**OPERABLE UNIT 4; SUBMISSION OF COMMENT RESPONSES AND REQUESTS  
FOR EXTENSION OF RESUBMITTAL PERIOD FOR THE SILO  
SUPERSTRUCTURE FINAL (100 PERCENT) DESIGN PACKAGE**

**OPERABLE UNIT 4; SUBMISSION OF COMMENT RESPONSES AND REQUEST FOR  
EXTENSION OF RESUBMITTAL PERIOD FOR THE SILO SUPERSTRUCTURE FINAL (100%)  
DESIGN PACKAGE**

RESPONSE TO USEPA  
TECHNICAL REVIEW COMMENTS ON THE "PRE-FINAL DESIGN, SILO  
SUPERSTRUCTURE FOR THE FERNALD RESIDUES VITRIFICATION PLANT,"  
DATED MAY 1996

PROJECT TITLE  
**SOIL MANAGEMENT FOR FRVP SILO SUPERSTRUCTURE CONSTRUCTION**

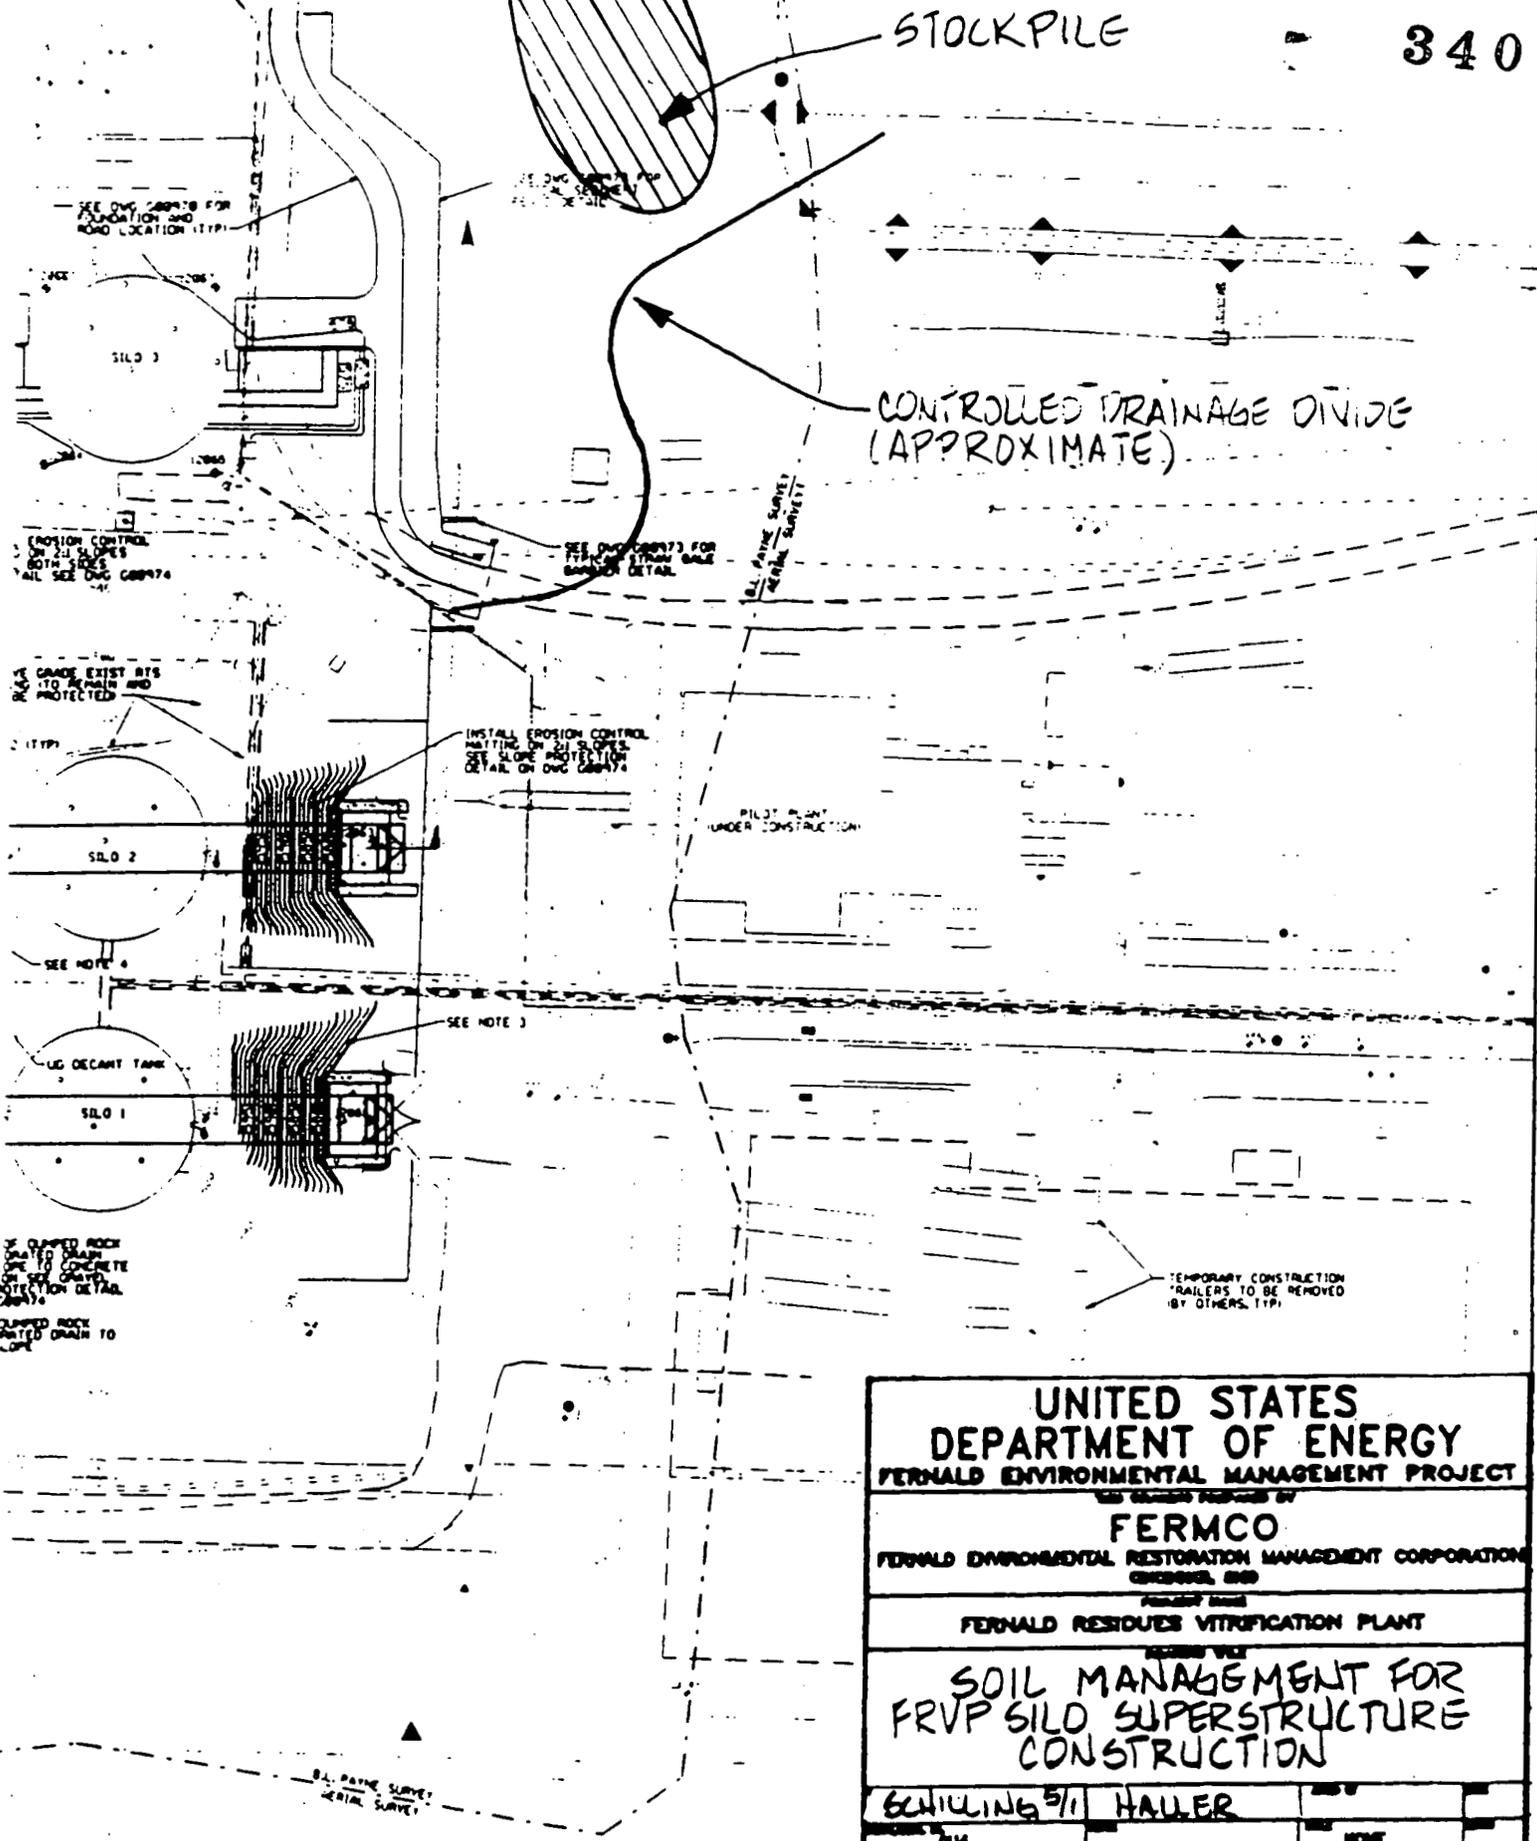
- 9) Commenting Organization: Ohio EPA  
 Section #: General Comment  
 Original Comment #:  
 Comment: During construction activities, how will be (sic) determination between Category I and Category II soils be performed? How long will Category II soils be stockpiled?

Response: See revised text (attached) for clarification of the Soil Management approach during Silo Superstructure construction. "Category I" and "Category II" soil designation was intended as an interim soil management tool for activities and projects other than remedial design/remedial action projects. Since this project is considered a remedial design/remedial action activity, the Category I and Category II designations should not have been used.

Approximately 3300 cubic yards (yd<sup>3</sup>) of excess soil will be generated during construction of the FRVP Silo 1 and 2 Superstructures and Silo 3 Equipment Enclosures foundation excavations. This soil will be temporarily staged, as necessary until placement into the OSDF, east of Silo 3 and the proposed relocated road and southwest of the biosurge lagoon (see attached figure).

If it is necessary to temporarily stockpile soil prior to placement into the OSDF, the proposed area is within the limits of the Waste Pit perimeter area runoff controlled boundary previously established by Removal Action 3 such that the runoff from the stockpile will be controlled. Erosion control for the stockpiles will be implemented and maintained and may include a tarpaulin cover, seeding, silt fencing, dust suppressants, or crusting agents.
